**Changed Pages**

**Part III, Appendix III-D.3**

**Landfill Design and Details**

**Pescadito Environmental Resource Center**  
**MSW No. 2374**  
**Webb County, Texas**

FINAL COVER DETAILS

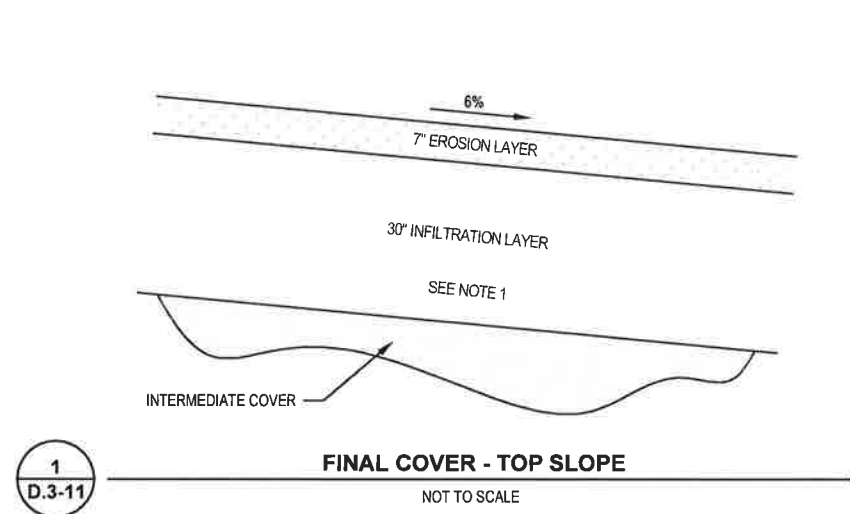
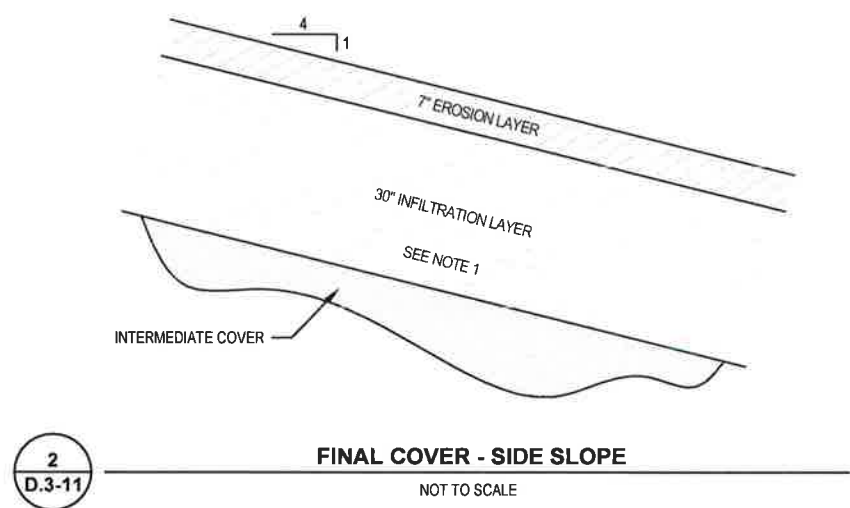
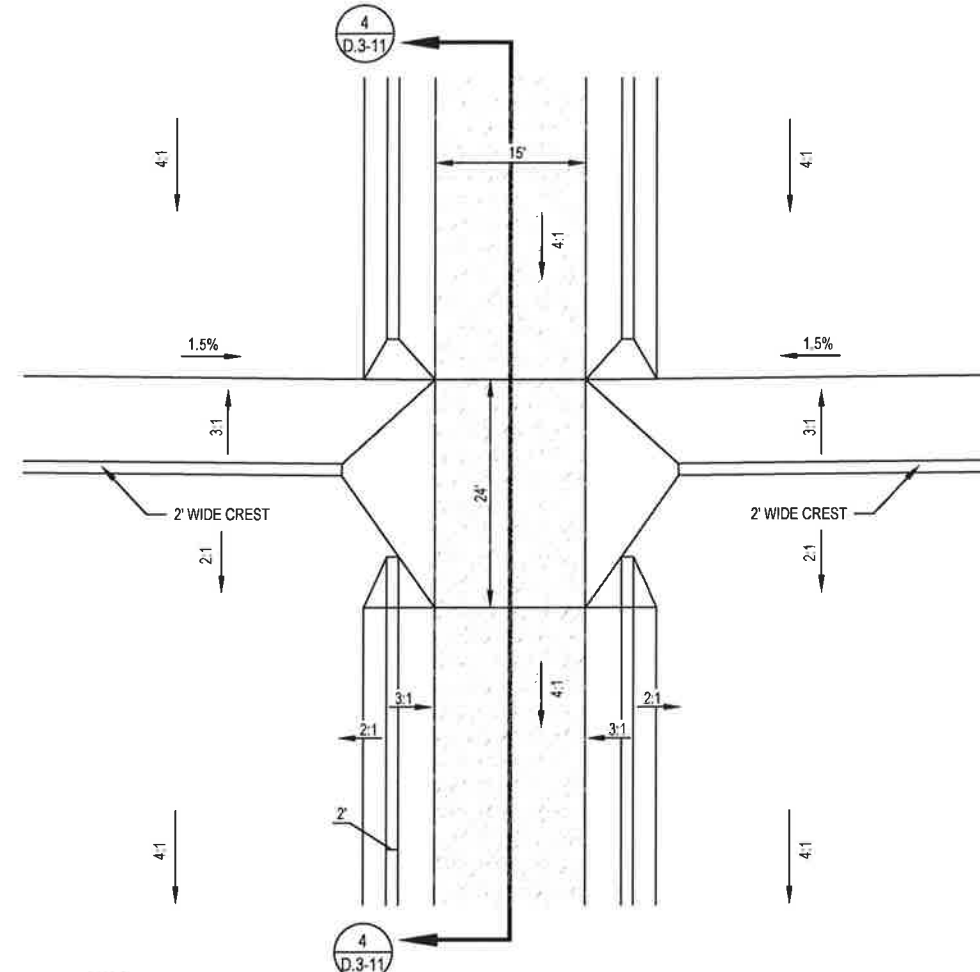
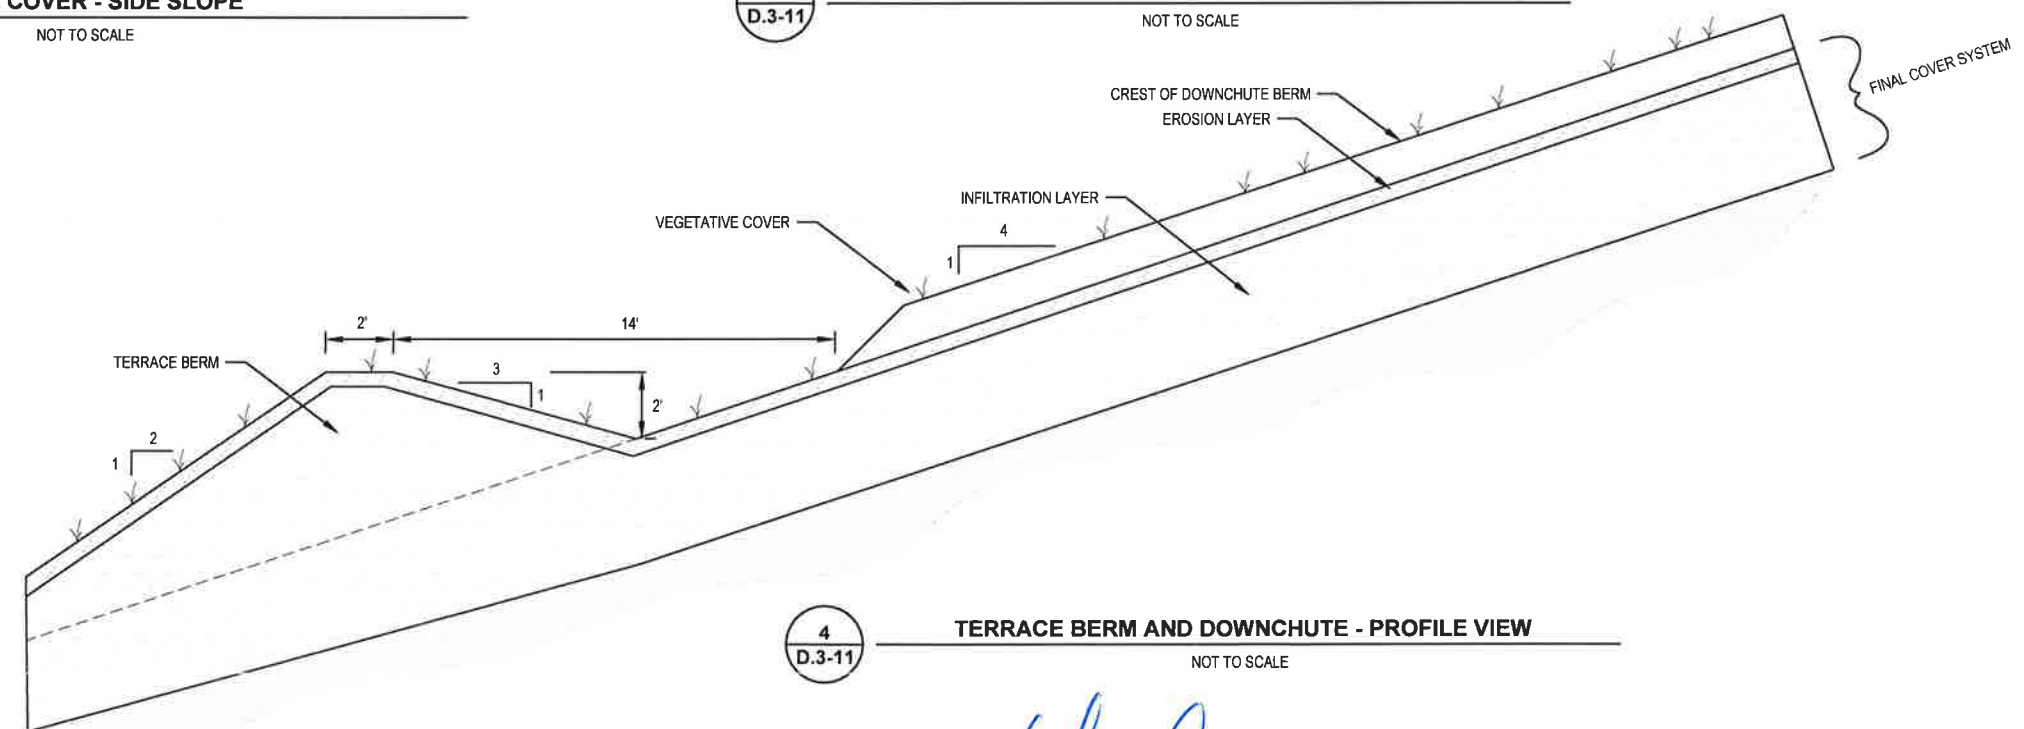
REV. NO.	DATE	DESCRIPTION
1	8/2016	REVISED CALL OUTS; ADDED NOTE 1

NOTES:  
1. FINAL COVER SYSTEM IS DESCRIBED IN APPENDIX III-D.8. IF CLASS I INDUSTRIAL WASTE IS PLACED IN THE CELL, A FML AND DRAINAGE LAYER WILL BE INCLUDED IN THE FINAL COVER SYSTEM OVER THE CELL.
